MEMORANDUM

Date: January 5, 2026
To: Planning and Zoning Members
From: Dinh V. Ho, P.E.
RE: KIA Dealership – Lighting Variance
Staff's Summary and Recommendations
CC: Mayor Wil Kennedy, Natasha Brooks, Kayleen Rosser

The variance request is to allow for increase in exterior lighting levels (foot-candles and lumens) during business hours only.

10000 ALLIANCE RD. CINCINNATI, OHIO 45242 USA (513) 793-3200 * FAX (513) 793-6023	
<h1>LIGHTING PROPOSAL</h1>		L0-161061-5	
<p>PARKWAY KIA STATE HWY 288 ROSHARON, TX</p>			
BY:AHK,SEF	DATE:09/23/24	REV:10/22/25	SHEET 1 OF 1
SCALE:1"=40'		0	40

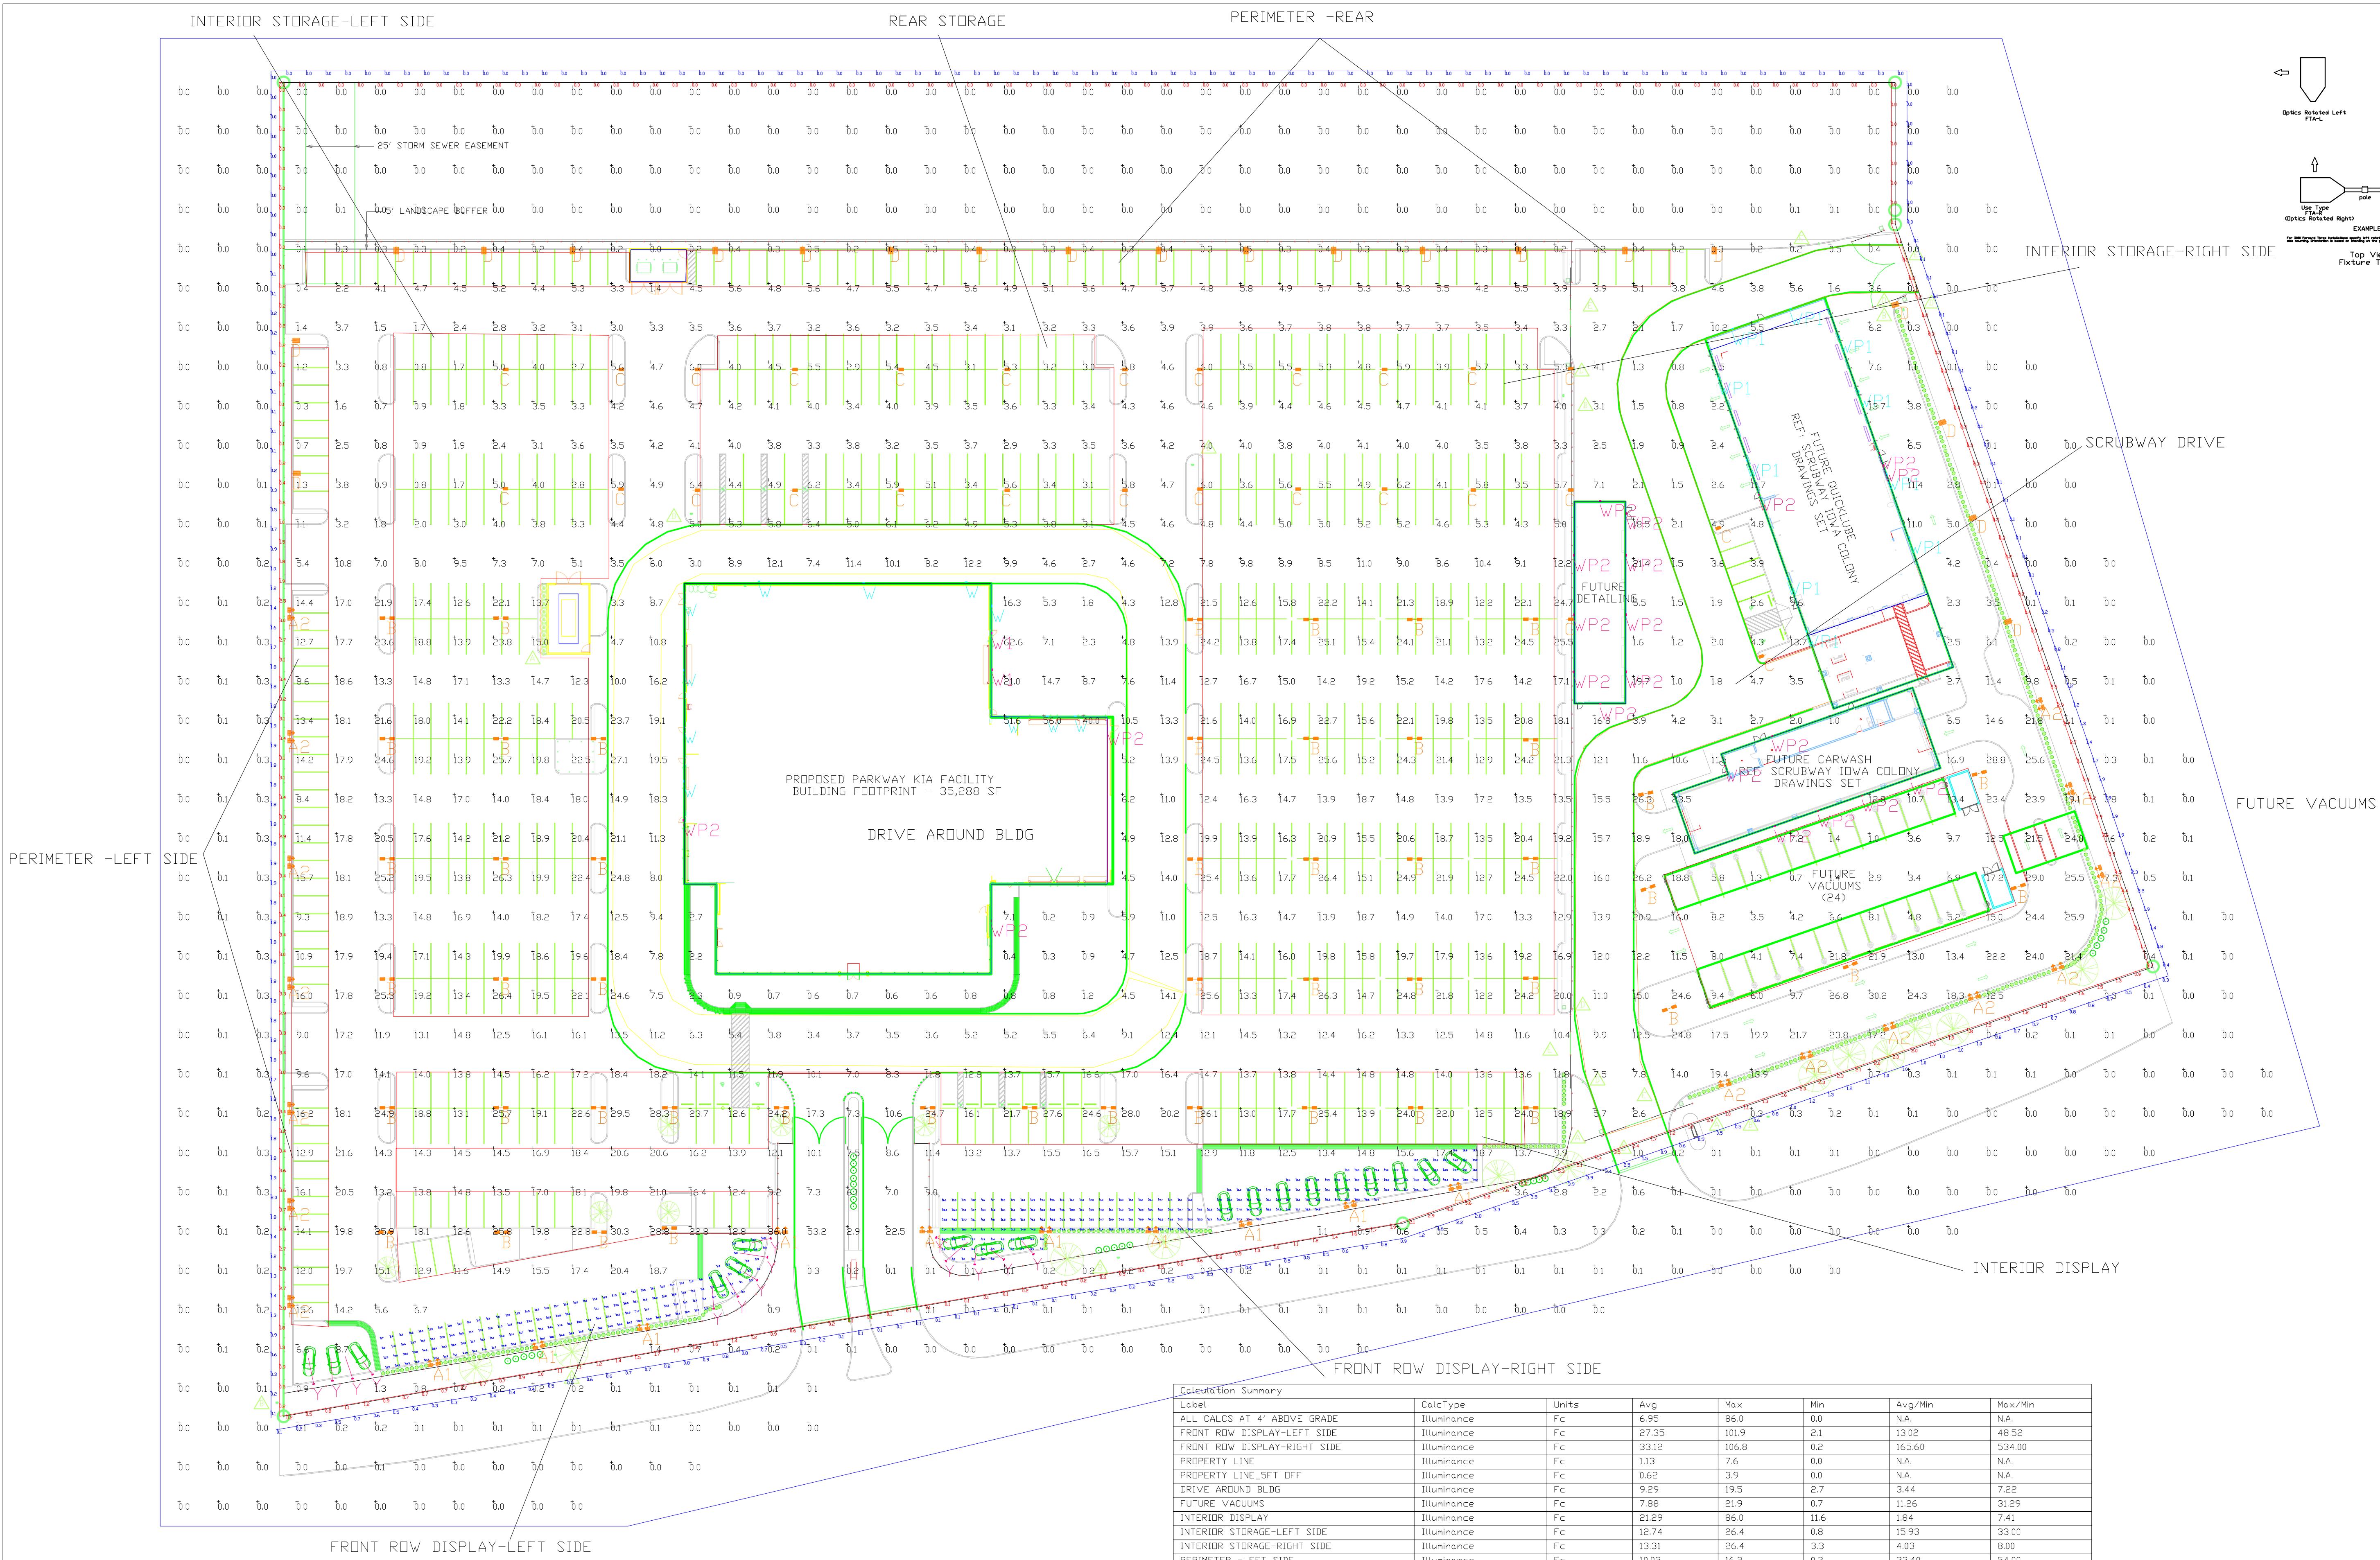
2. Increased illumination is directly related to **vehicular and pedestrian safety**, particularly for customer circulation, inventory protection, and visibility across large parking and display areas typical of automotive sales facilities.

4. Limited Adverse Impact to Adjacent Properties - The submitted photometric heat maps show lighting concentrated internally within parking and display areas, with perimeter levels controlled to prevent excessive spillover onto neighboring properties or public rights-of-way.

1. Increased lighting levels shall be permitted during business hours only (7:00 AM – 9:00 PM)
2. All exterior lighting shall automatically dim or reduce after business hours to comply with City lighting standards.
3. Lighting shall be installed and maintained per the approved photometric plans.
4. No additional fixtures or increases in illumination beyond what is shown on the approved plans shall be permitted without further review and approval.
5. Any verified lighting nuisance or spillover may require corrective action at the owner's expense.

LIGHTING PROPOSAL LD-161061-5A
PARKWAY KIA STATE HWY 288
ROSHARON, TX
BYAHK-SEF DATE 09/23/24 REV 10/22/25 SHEET 1 OF 1
SCALE: 1"=40'
0 40

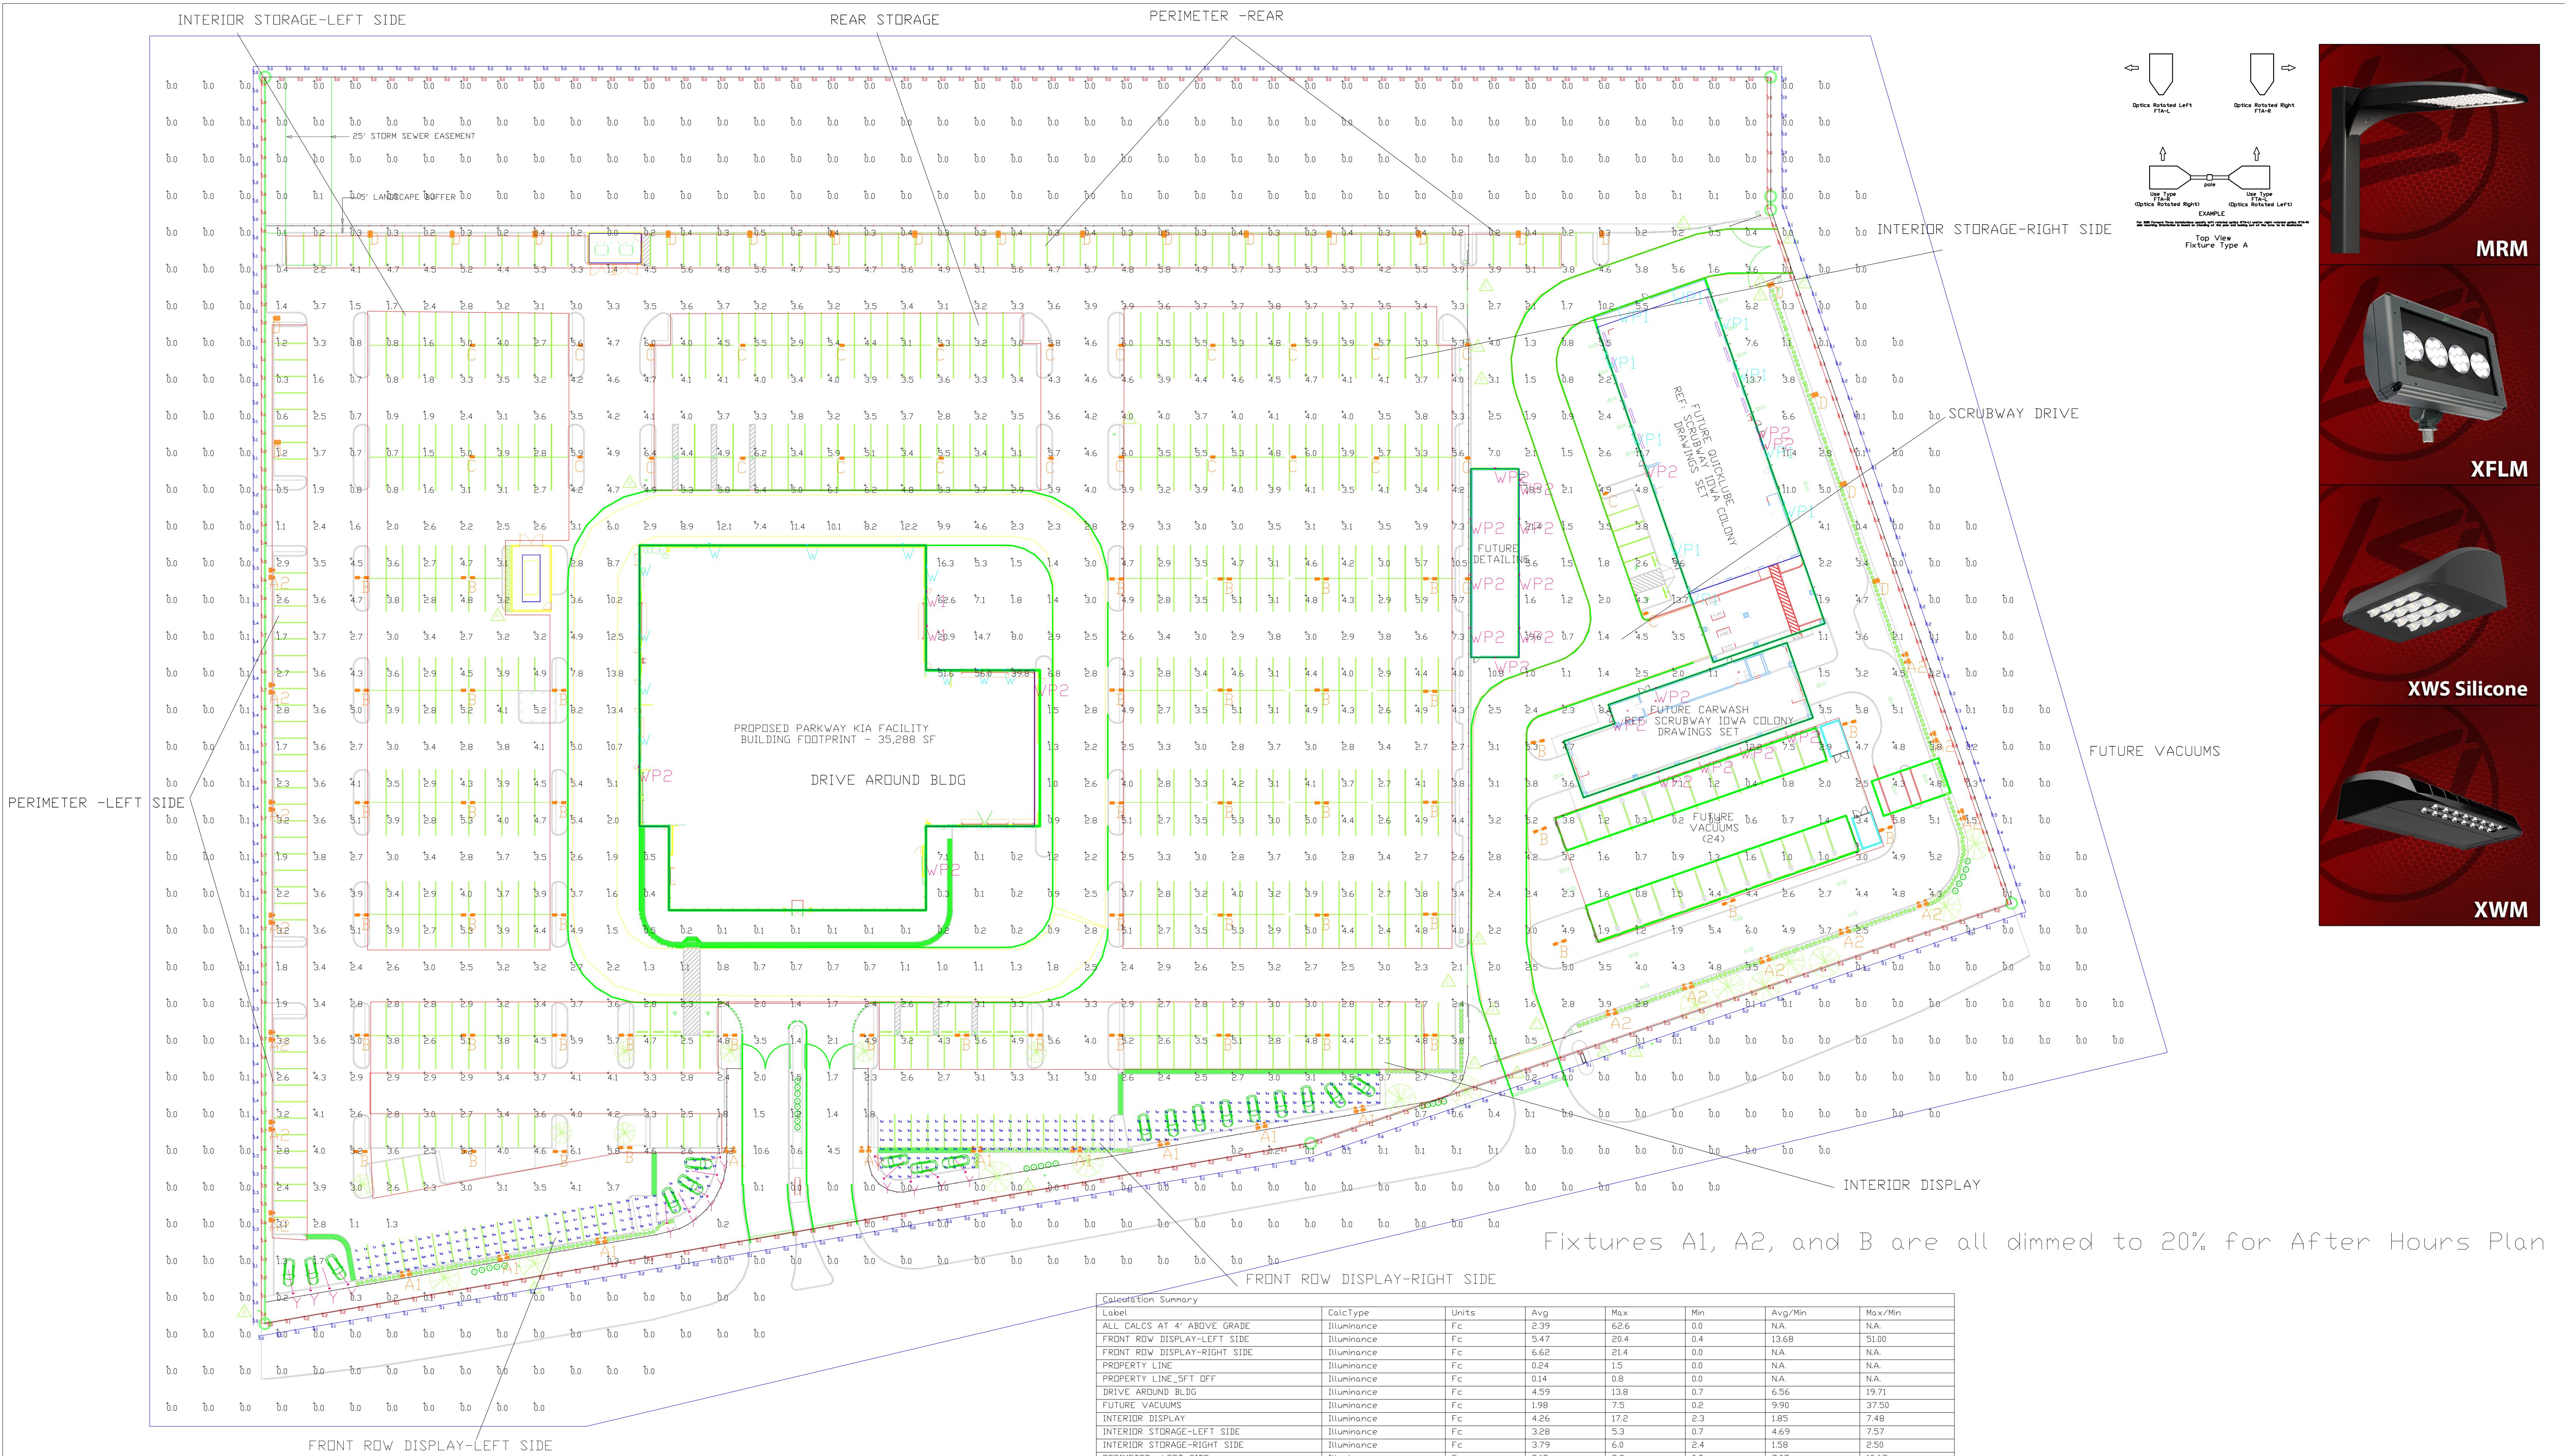
3. Compliance After Business Hours - Photometric plans demonstrate that **after-hours lighting levels meet UDC requirements**, minimizing light trespass, glare, and off-site impacts on adjacent properties.
